Appendices

Correspondence Supplied to Planning and Infrastructure NSW in Response to Final Feedback from Government Agencies and Public Authorities

SUBJECT: Response to government agency recommended conditions of consent

Dubbo Zirconia Project - Response to Submissions

Att: Figure 1 (of RTS)

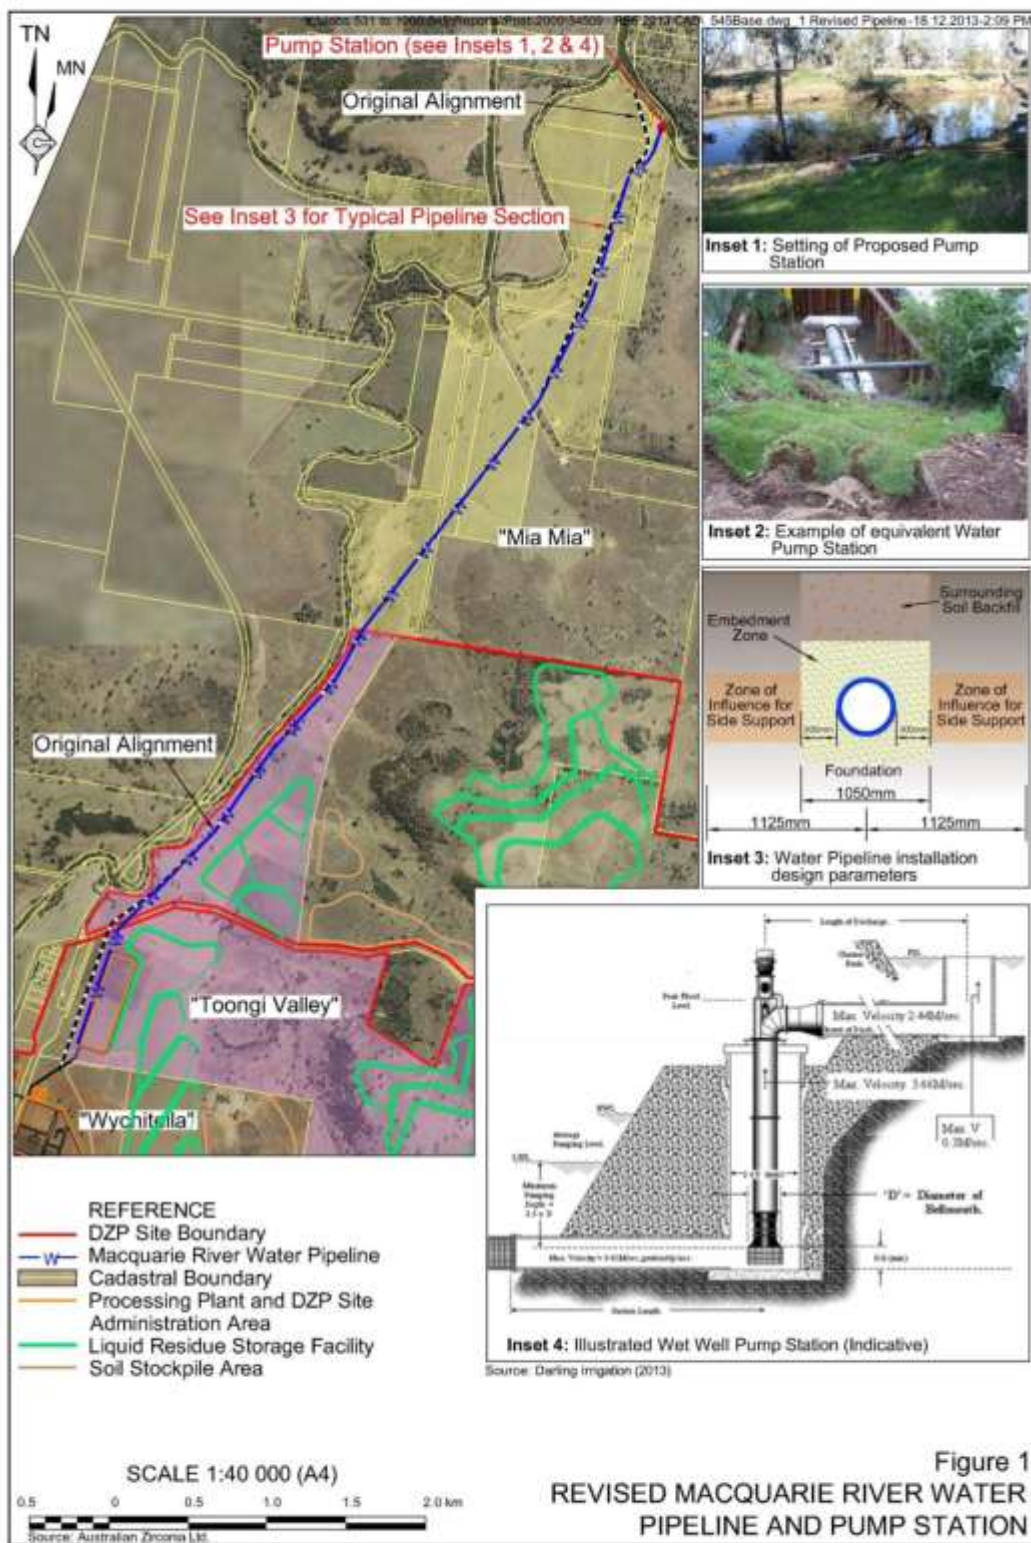
I refer to your email query of 21 March 2014 in relation to the assessment of noise generated by water pumping from the Macquarie River (**Figure 1** of the Response to Submissions identifies the proposed location).

Figure 2.15 REVISED
Letter Report of Constructive Solutions (DZP Reagent Haulage Routes BR100414.pdf)

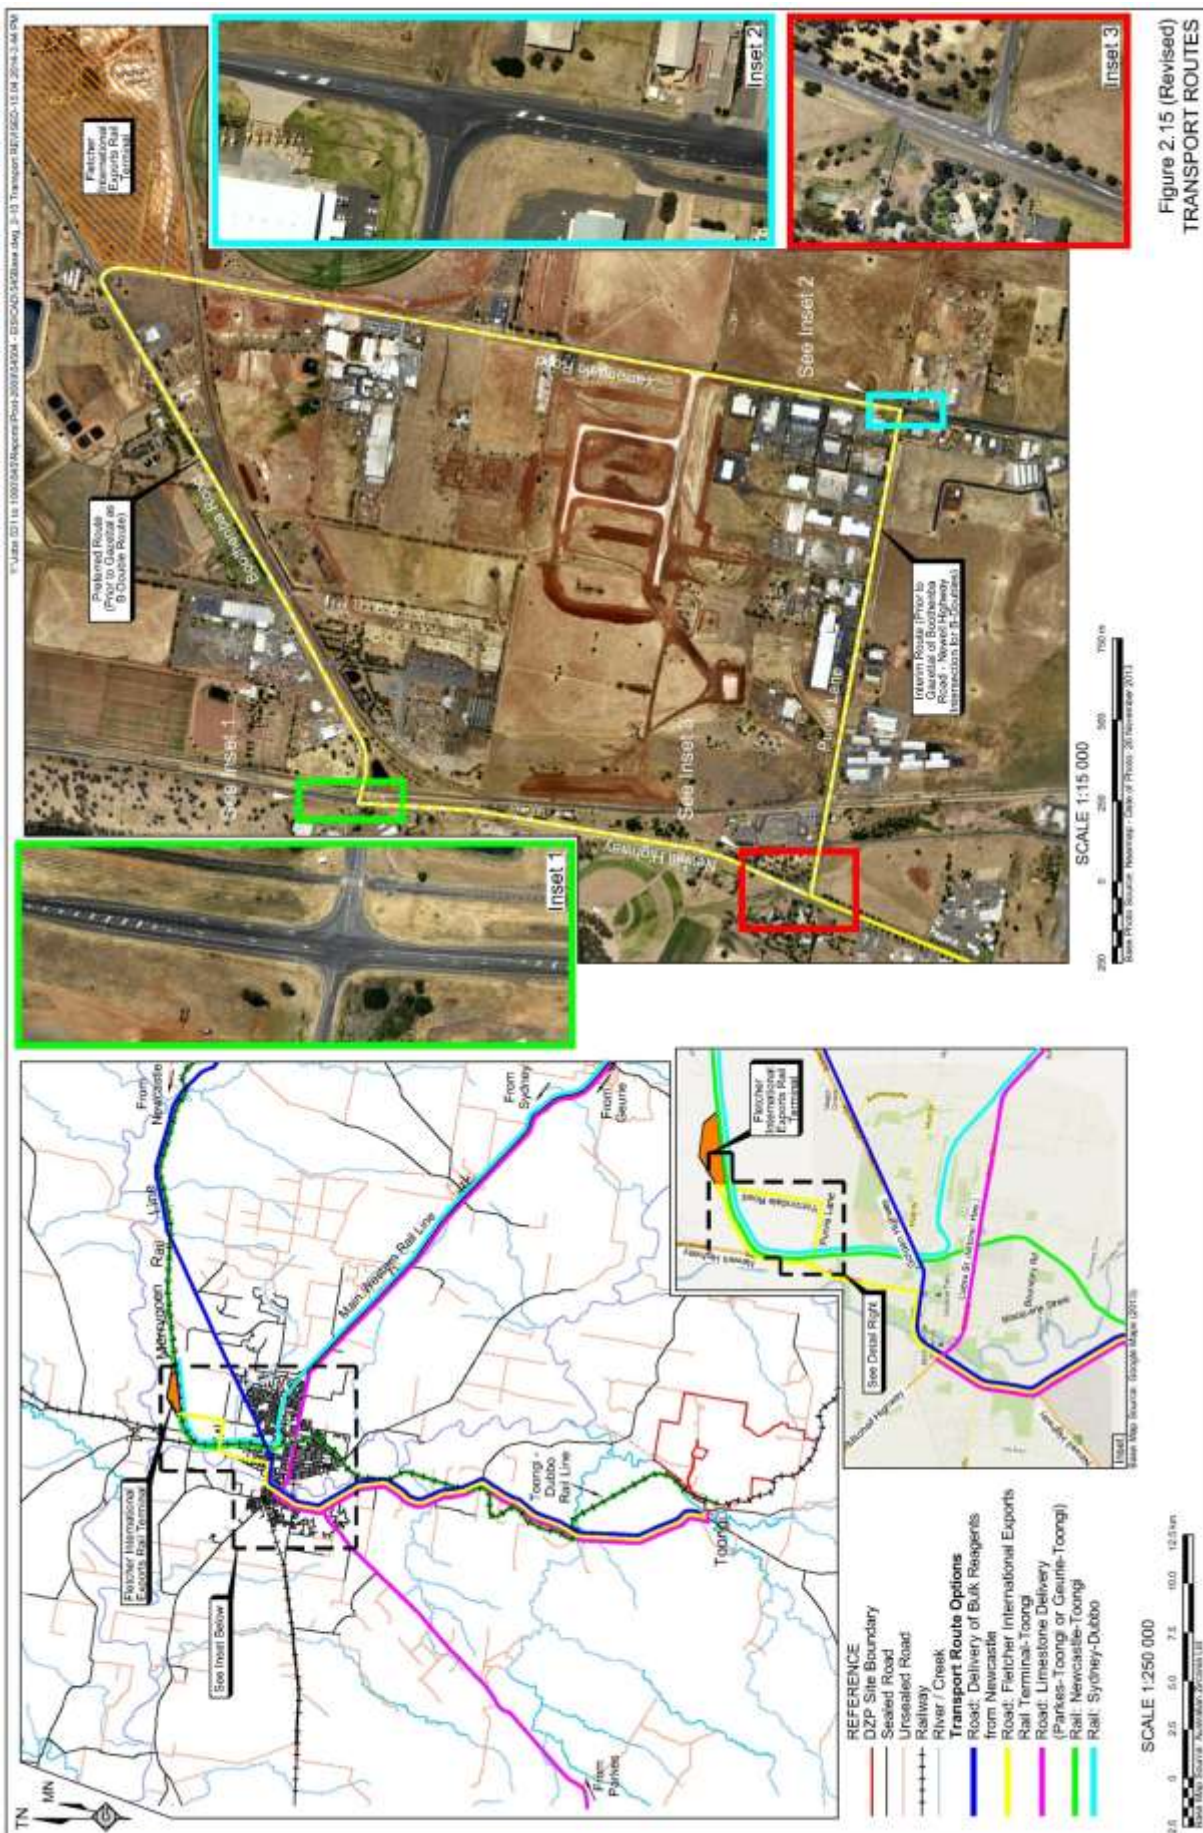
- Supply a revised **Figure 2.15** showing the new route via Purvis Lane.

*As discussed subsequently, the two routes in question from Fletcher International Exports are both considered suitable routes for the movement of reagents between the rail network and the DZP Site. As such, **Figure 2.15 REVISED** has been updated to include both. Additional insets have been included presenting recent aerial photography of the three key intersections associated with the Boothenda Road and Purvis Lane routes between Fletcher International Exports and the Newell Highway.*
